ADDENDUM NO. 1

RFP No. 15-0428

RFP Title: Purchase and Installation of Generator, Transfer Switch and Misc. Electrical Work at Fire Station 90 / 104

The purpose of this addendum is to supply vendors with electrical plans and address questions received to date.

ELECTRIC PLAN

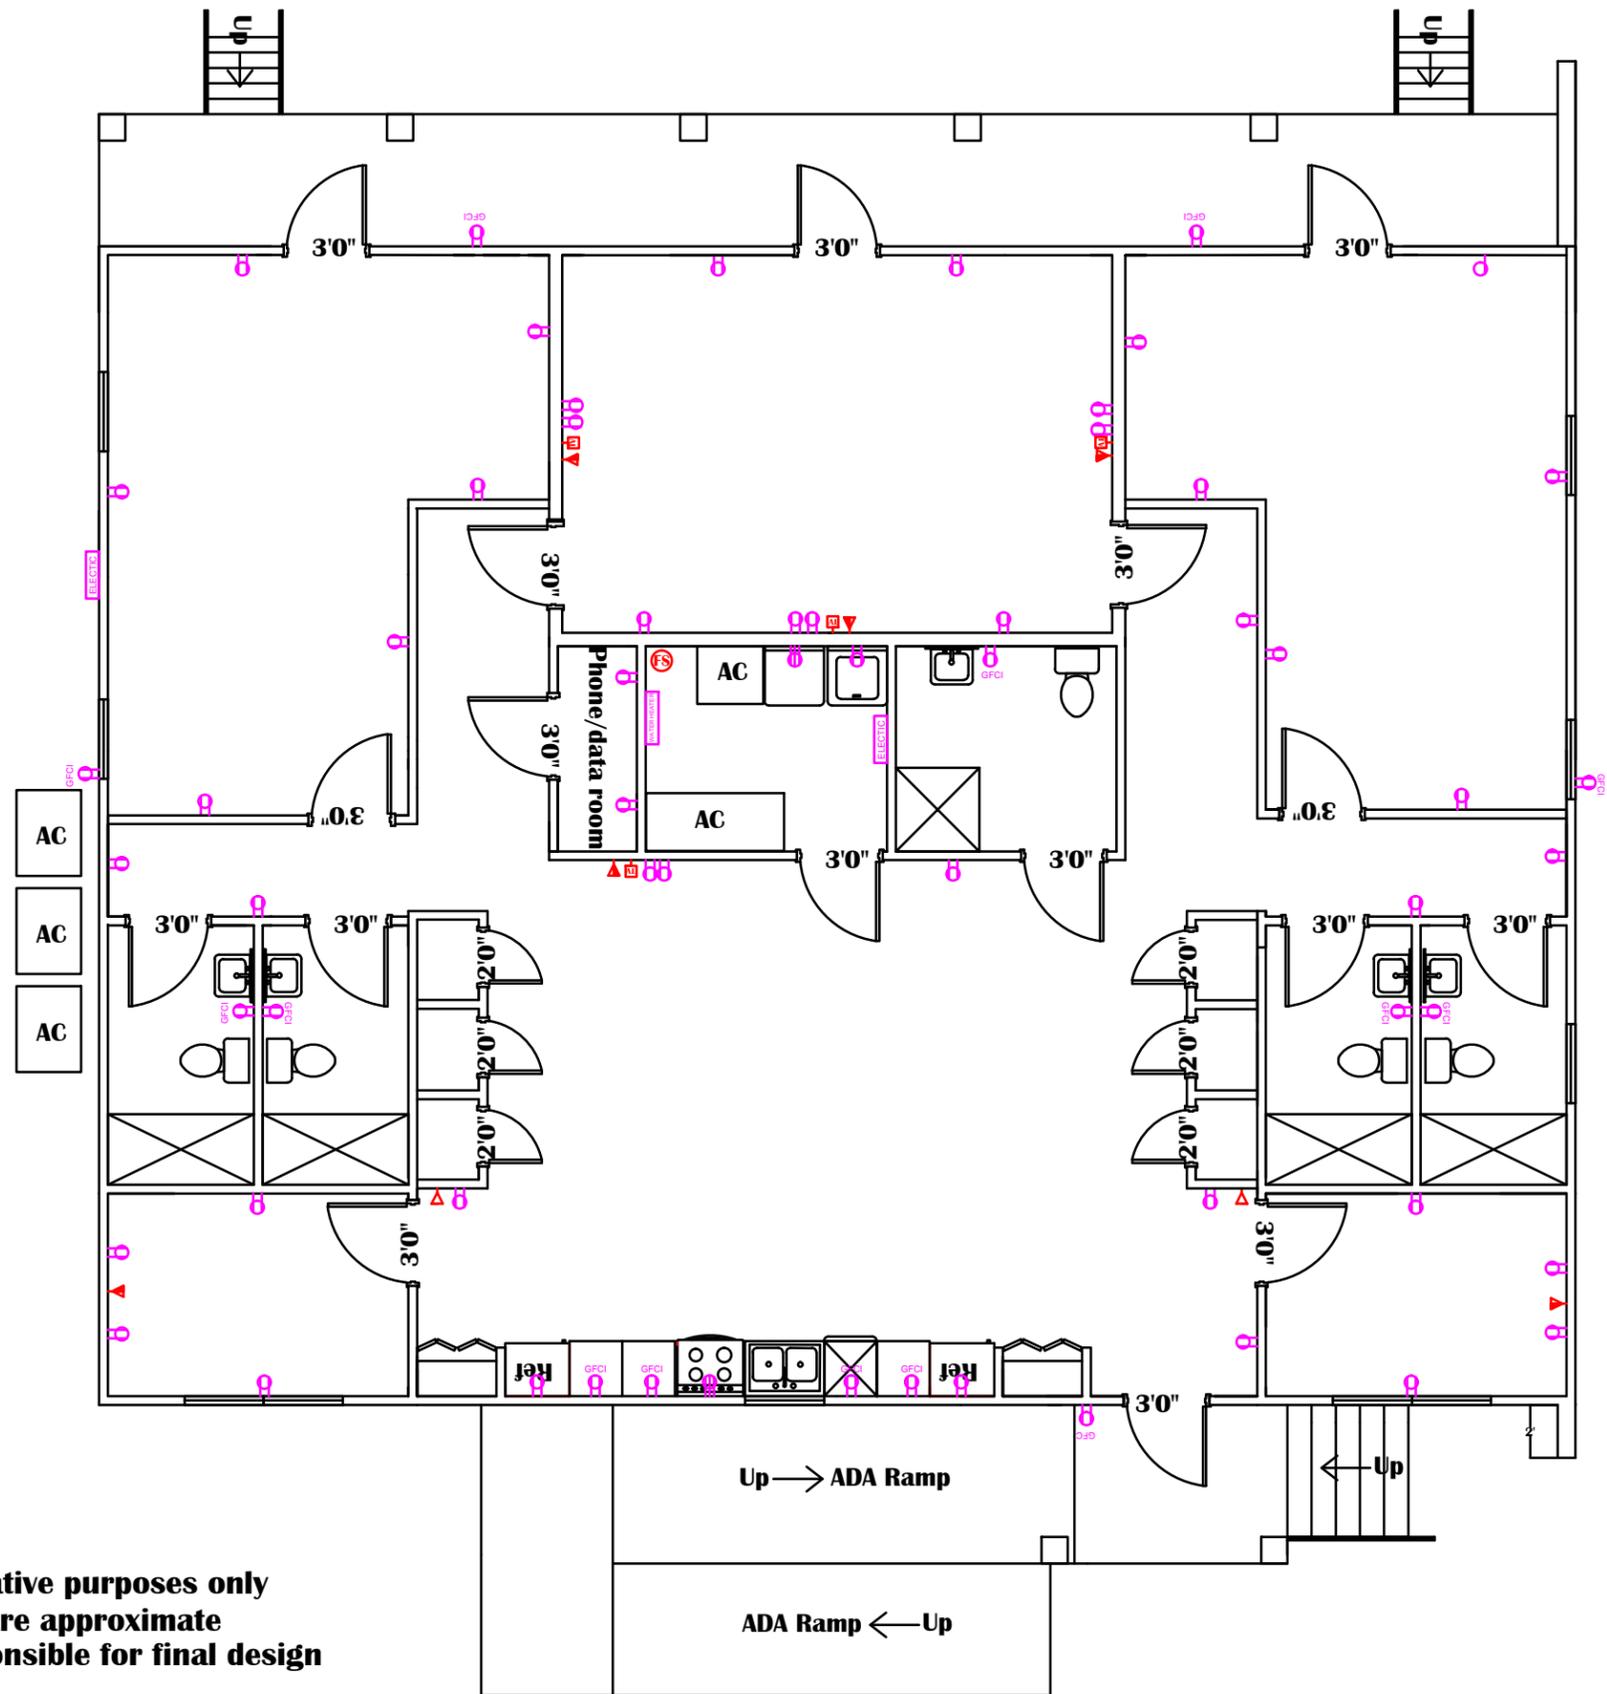
Question 6: Where is the location of main service equipment be in relative to the generator location?

Question 9: Will there be a panel or loadcenter with available capacity for the outlets under the canopy, the lock heater and battery charger?

Answer 6: See site plan and electrical drawing

Answer 9: The receptacles added on the canopy will be powered from the main service (see electric drawings and site plan for locations).
